Title: Permit 25-381: 4685 and 4735 West Branch Road Culverts

Applicants: Ryan Ortlip (4685 West Branch Rd)
Clarke Reed (4735 West Branch Rd)

Prepared by: Maggie Menden
mmenden@minnehahacreek.org

Recommended Permit Conditions

DRIVEWAY PLAN
WEST BRANCH ROAD
ORTLIP

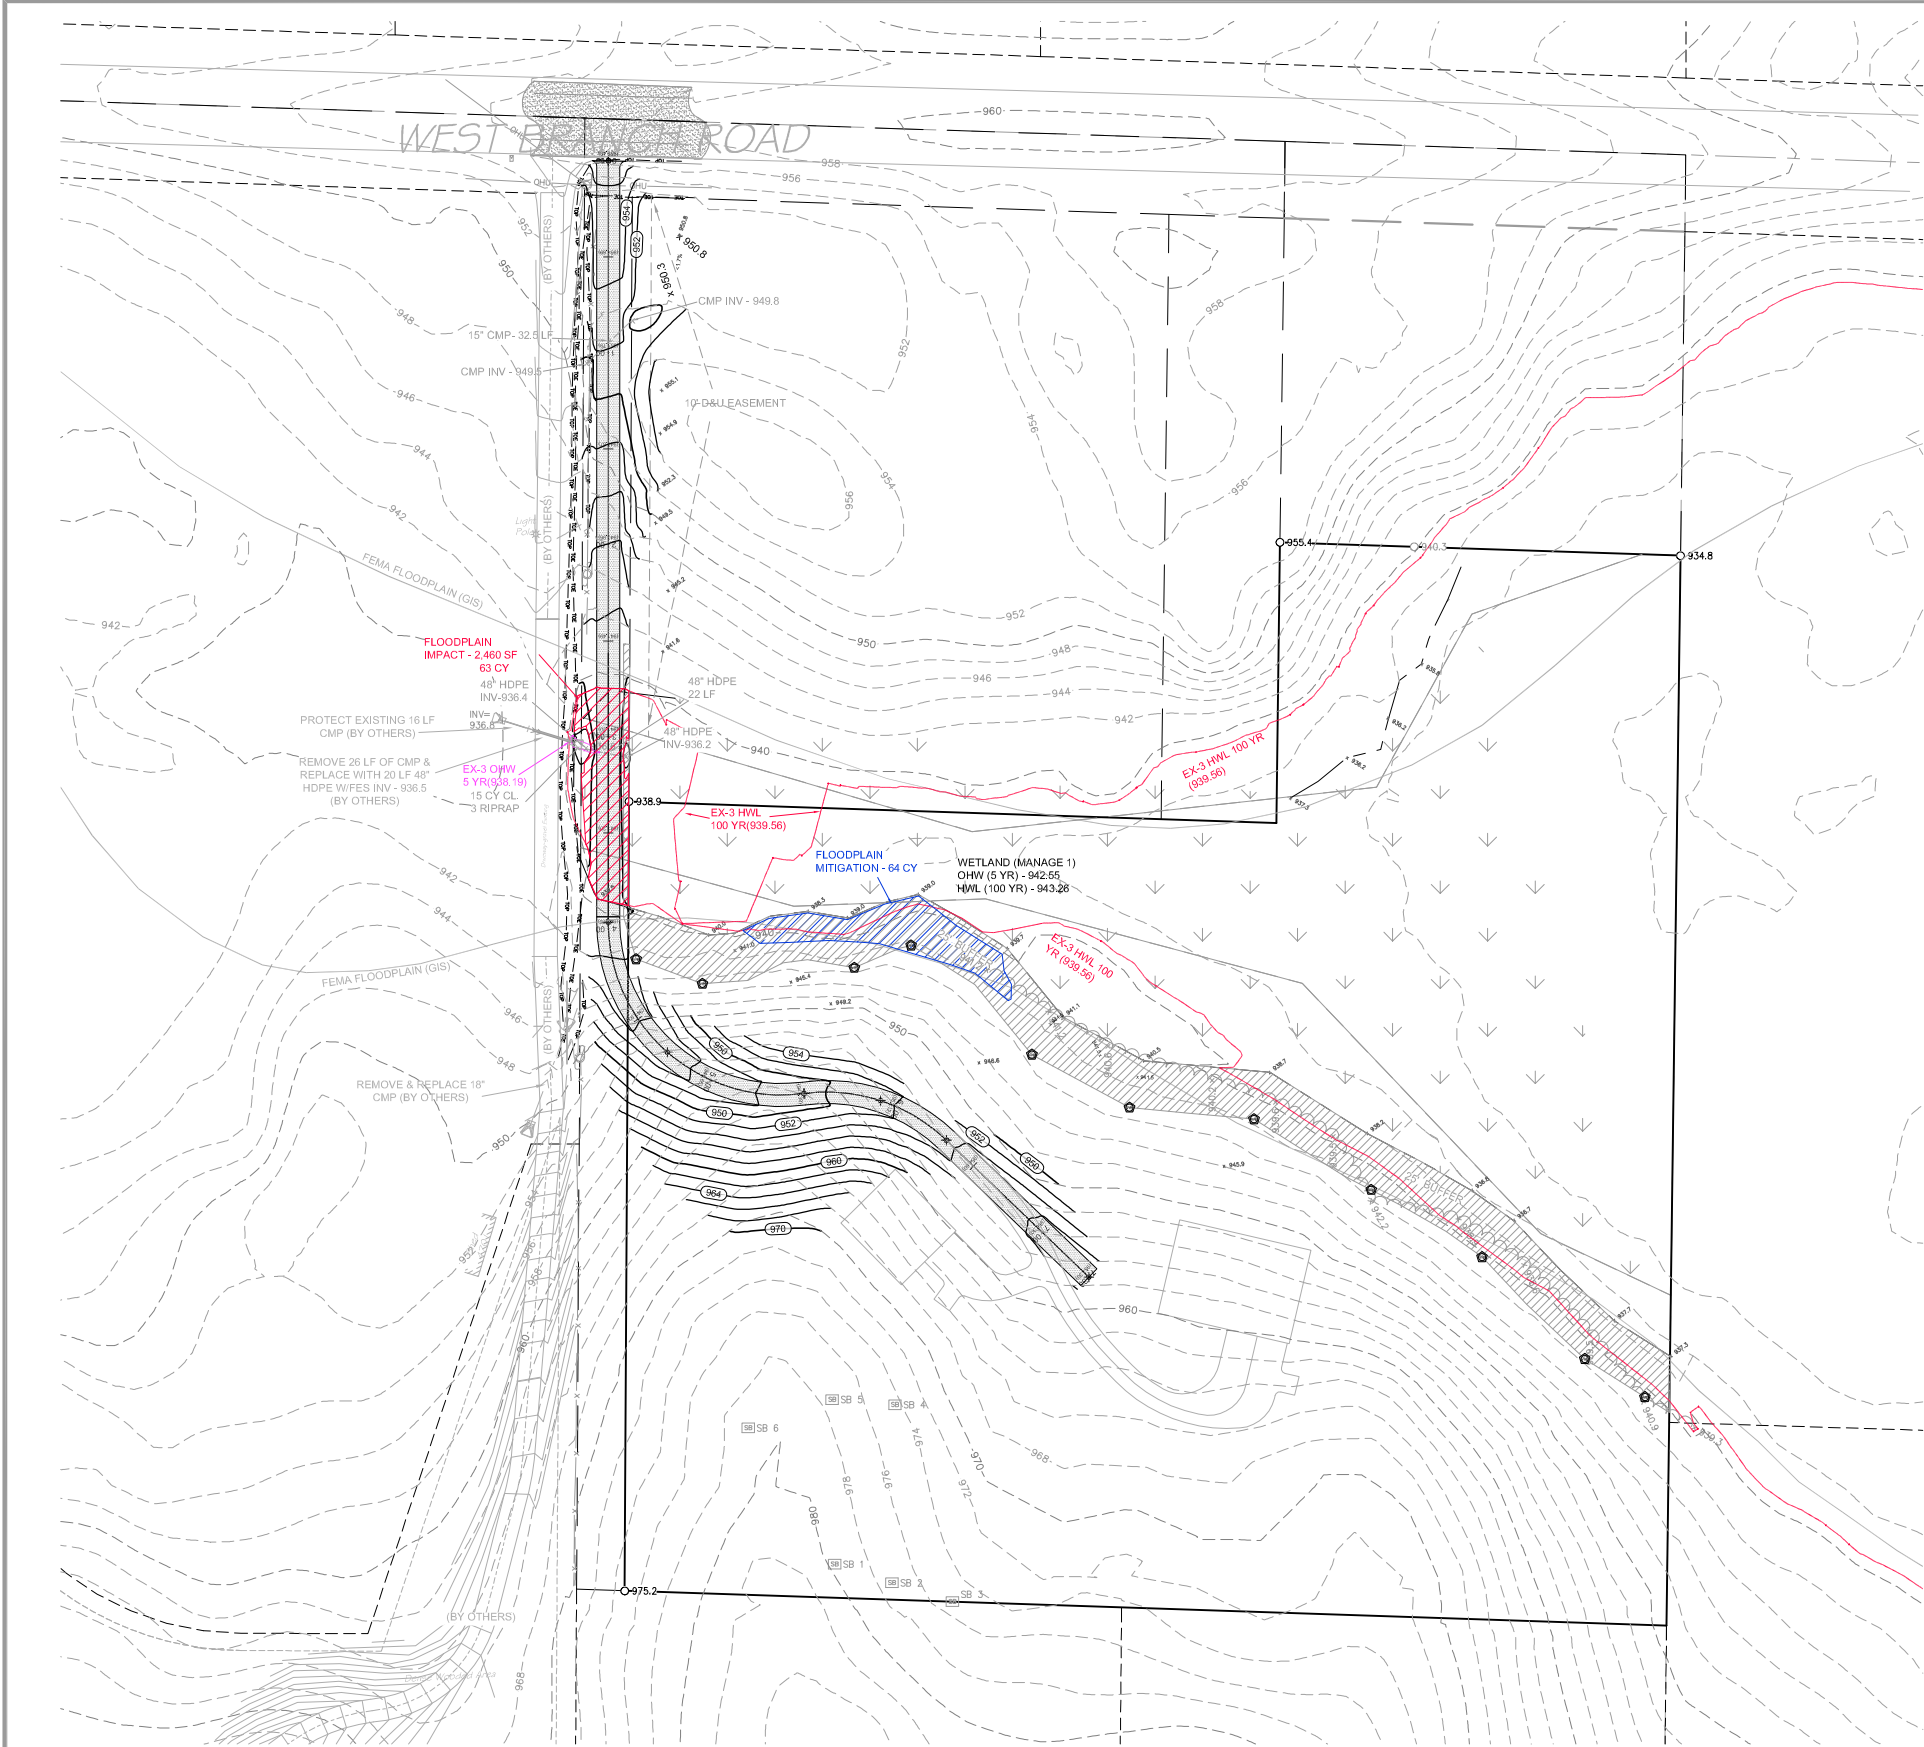
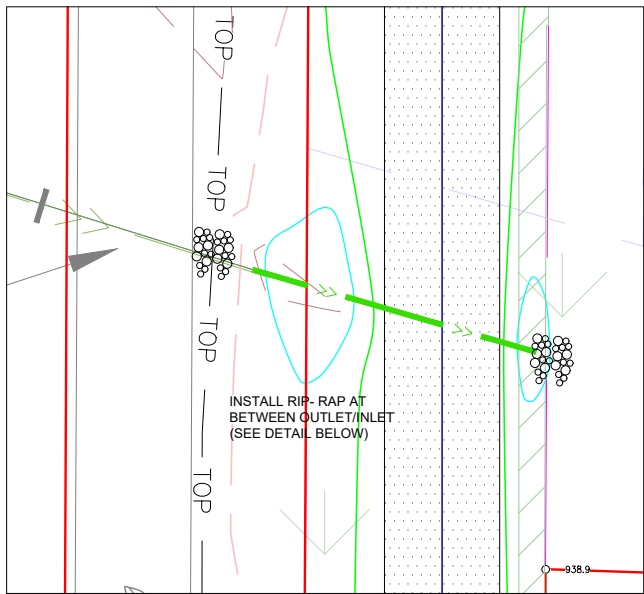
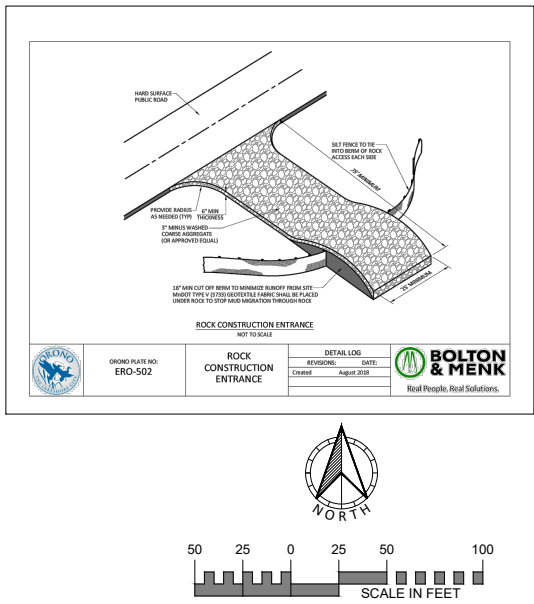
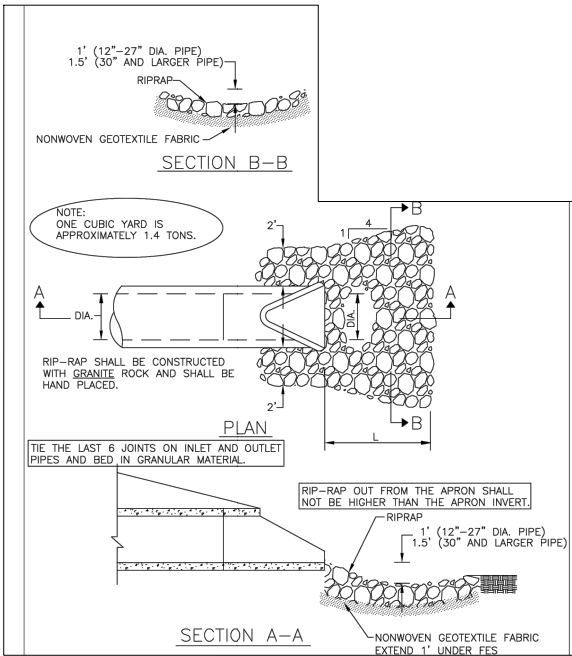
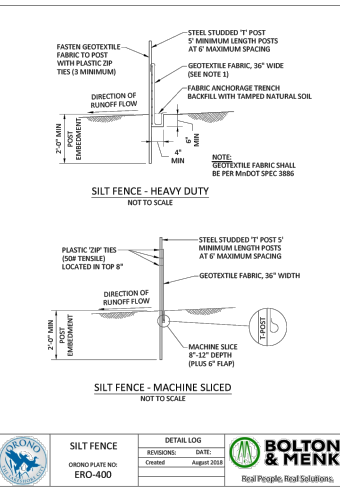
The resident also raised concerns about both the pipe material and size. He expressed a preference that the culvert at 4735 remain metal, consistent with the existing condition, and that it be upsized to provide additional capacity. He also expressed concern that the existing gravel driveway may be converted to pavement, noting that he operates heavy trucks and does not want to assume responsibility for maintaining pavement under the shared maintenance agreement.

The resident also questioned whether the existing culvert can adequately handle existing flow conditions. The proposed replacement is expected to improve hydraulic performance because HDPE pipe is smoother and more hydraulically efficient than the existing CMP, allowing it to more effectively convey flows downstream.

While the District does not prescribe specific design elements such as culvert material, size, or driveway surface, the comments were passed along to the Applicants for their consideration. Culvert design elements such as material, size, length, and inverts are involved in MCWD's regulatory review, but in the capacity that the District reviews projects to ensure that changes to these design elements will still allow the proposal to comply with applicable rules. In this case, Staff and the District Engineer evaluated the proposed culverts under the Floodplain Alteration and Waterbody Crossings & Structures Rules, focusing on whether the designs would affect upstream or downstream flood elevations. As discussed in the Rule Analysis section, the Project was found to meet all requirements.

Attachment C: Modeling Results

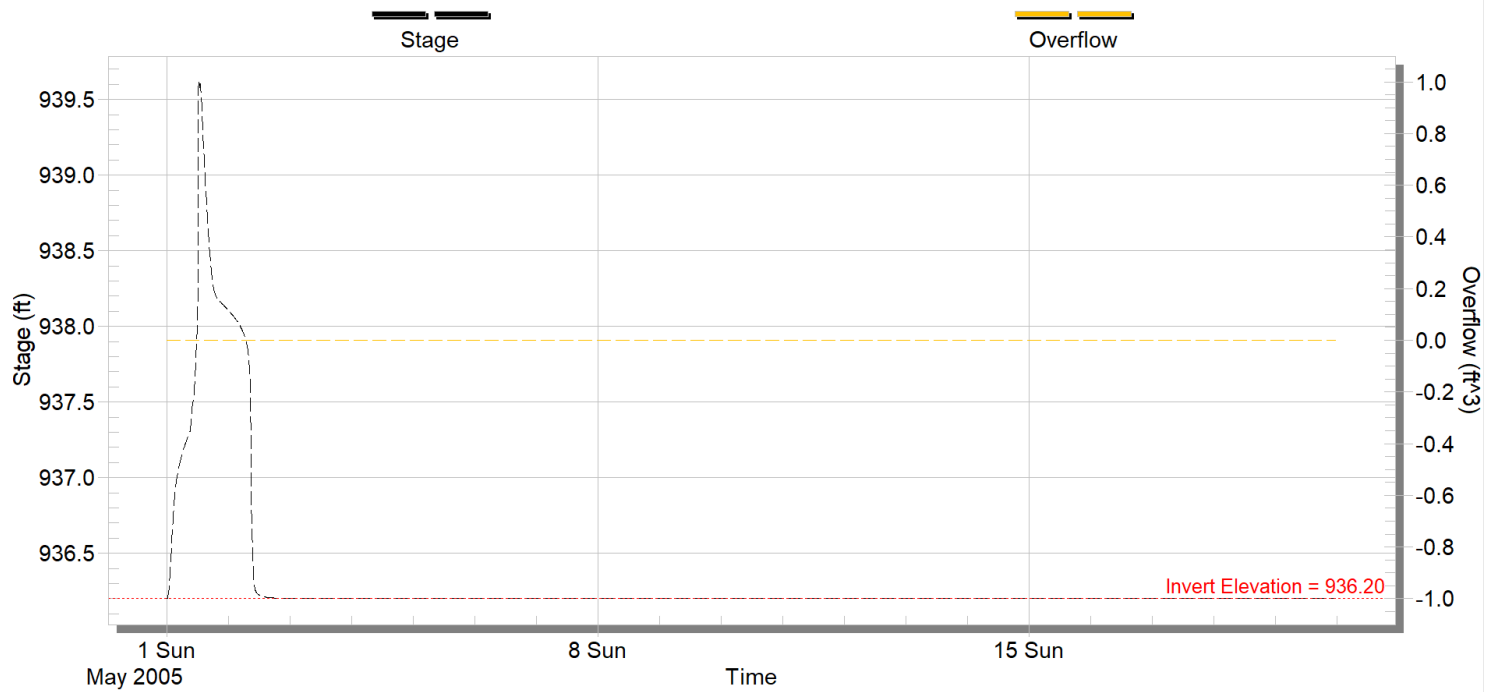
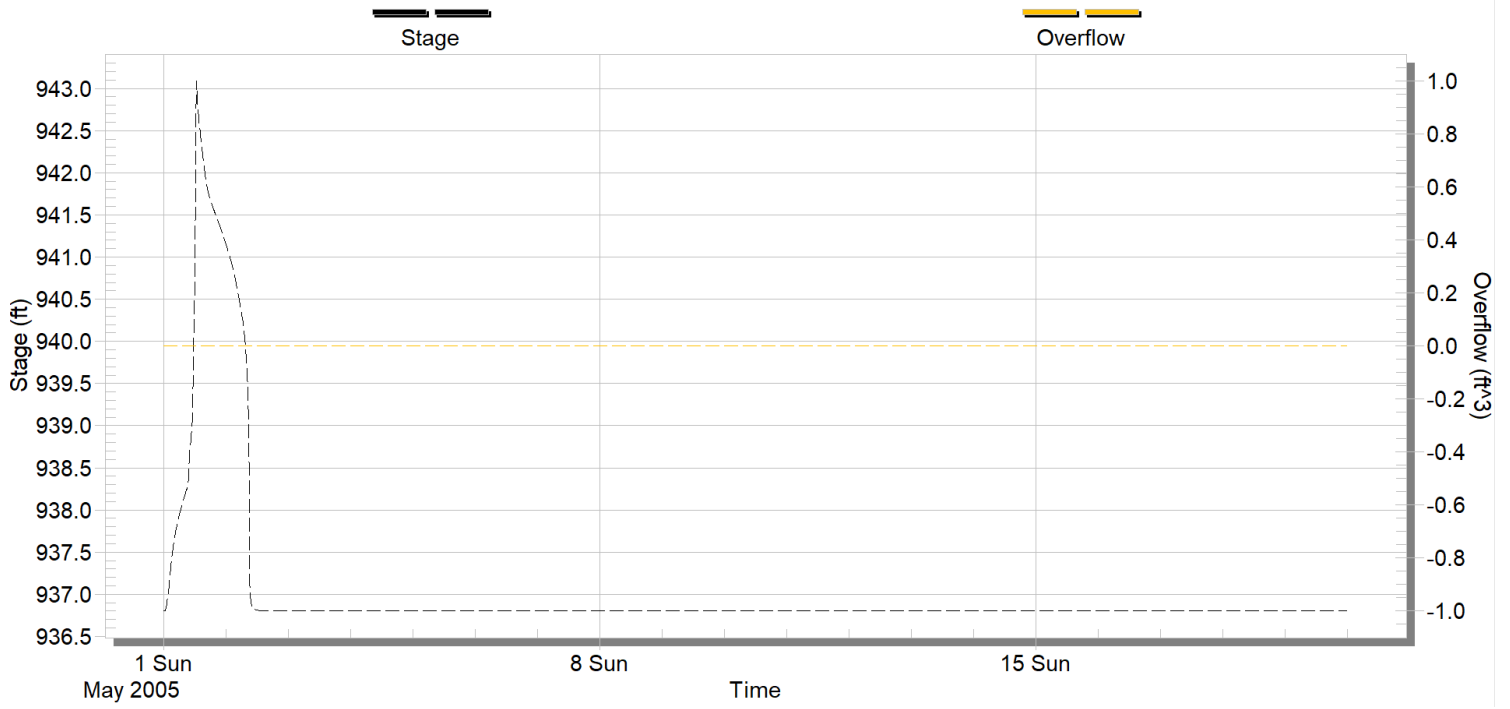
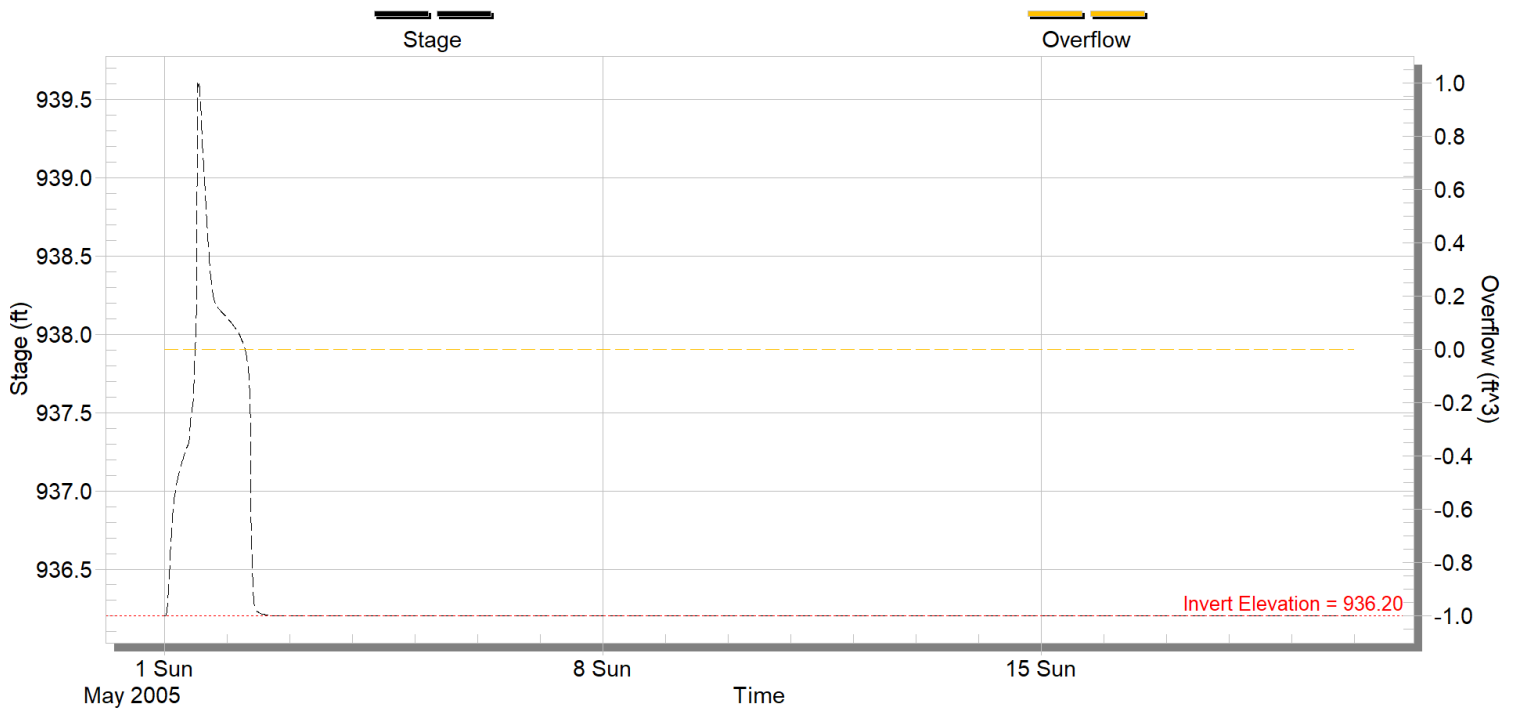
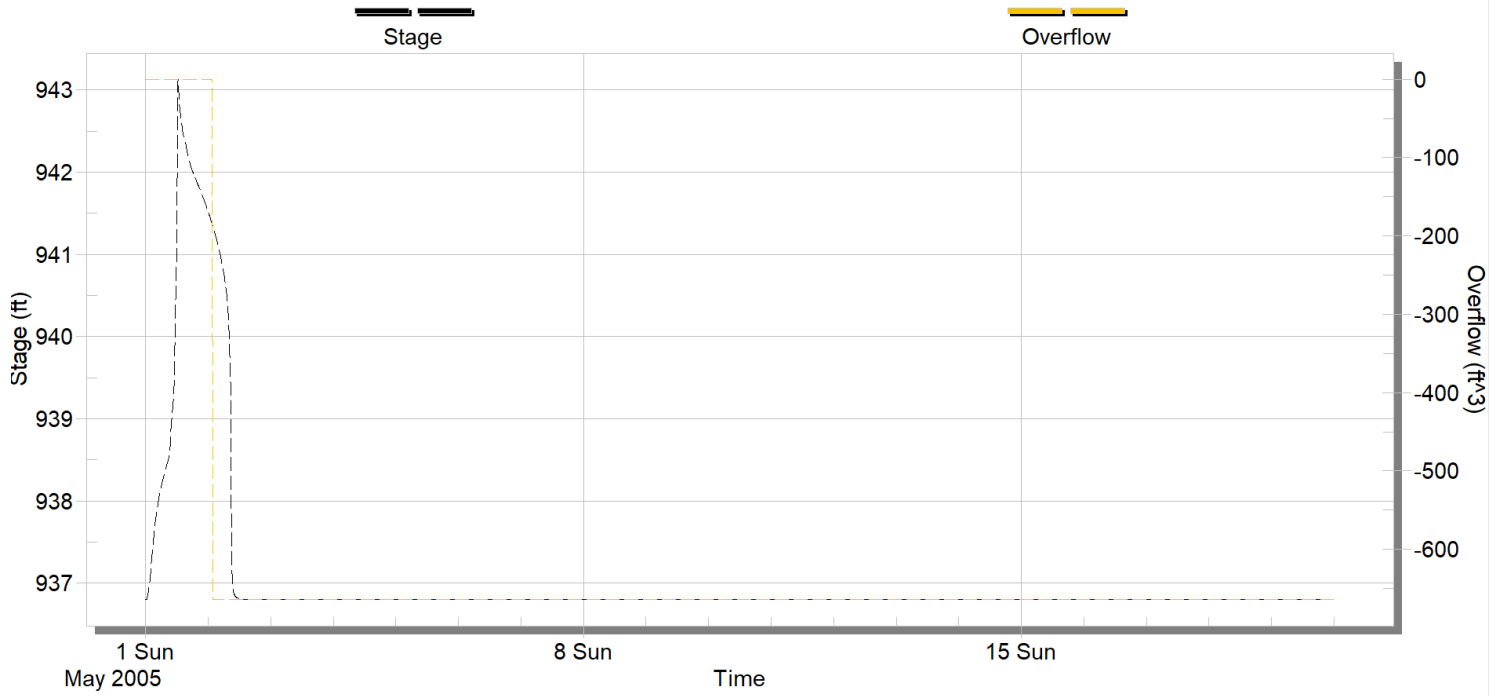
The resident expressed concern regarding the accuracy of the hydrologic and hydraulic (H&H) modeling, including questions about the 100-year high-water levels and flow rates.

To evaluate the proposed culvert configuration, the applicants used the District's XP-SWMM model to model hydrologic conditions for both existing conditions and the proposed configuration. District Staff and the District Engineer reviewed the model inputs, assumptions, and outputs to confirm that the modeling appropriately represents site conditions and is technically sound. The results show that during the 100-year storm event (7.4 inches of rainfall over 24 hours), upstream and downstream high-water levels are slightly reduced compared to existing conditions (see Table 3). This demonstrates that the proposed project is not expected to increase flood elevations on any properties and meets the District's No-Rise standard. The permit is being issued as a single permit to ensure that both culvert sections are installed together, in accordance with the modeled scenario. Regarding concerns about drainage between the existing and proposed driveways, Staff and the District Engineer reviewed this issue as part of the model assessment. Given the size of the contributing watershed (318 acres) and the existing drainage patterns from the hill to the south, the impact of the downstream driveway and culvert on local drainage is expected to be negligible. The separation of the upstream and downstream culverts allows the ditch between the two driveways to drain through the new downstream HDPE culvert.
